Intel® Desktop Board DG45ID

Specification Update

July 2010

Order Number: E49129-007US

Figure 14. Location of the Jumper Block

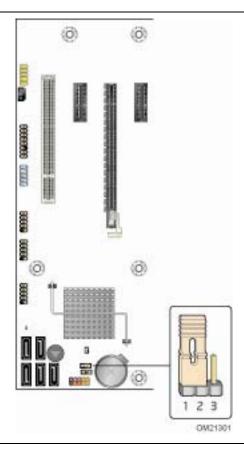
1. Corrected the Jumper numbering in Figure 14 of Section 2.3 Jumper Block.

Figure 8. Detailed System Memory Address Map

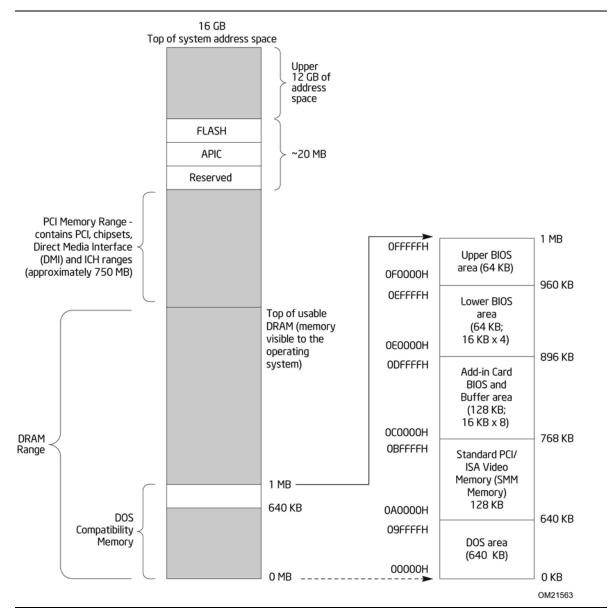
4. Support for up to 8 GB system memory has been changed to support for up to 16 GB system memory. Partial section of Table 1 shown below.

2.1.1 Addressable Memory

The board utilizes 16 GB of addressable system memory. Typically the address space that is allocated for PCI Conventional bus add-in cards, PCI Express configuration space, BIOS (SPI Flash), and chipset overhead resides above the top of DRAM (total system memory). On a system that has 16 GB of system memory installed, it is not possible to use all of the installed memory due to system address space being allocated for other system critical functions. These functions include the following:

- BIOS/ SPI Flash (32 Mbits)
- Local APIC (19 MB)
- Direct Media Interface (40 MB)
- Front side bus interrupts (17 MB)
- PCI Express configuration space (256 MB)
- GMCH base address registers, internal graphics ranges, PCI Express ports (up to 512 MB)
- Memory-mapped I/O that is dynamically allocated for PCI Conventional and PCI Express add-in cards
- Base graphics memory support (1 MB or 8 MB)
- Intel® Management Engine Interface (Intel® MEI) single channel (8 MB) or dual channel (16 MB)

The amount of installed memory that can be used will vary based on add-in cards, BIOS settings, and operating system installed. Figure 8 shows a schematic of the system memory map. All installed system memory can be used when there is no overlap of system addresses.
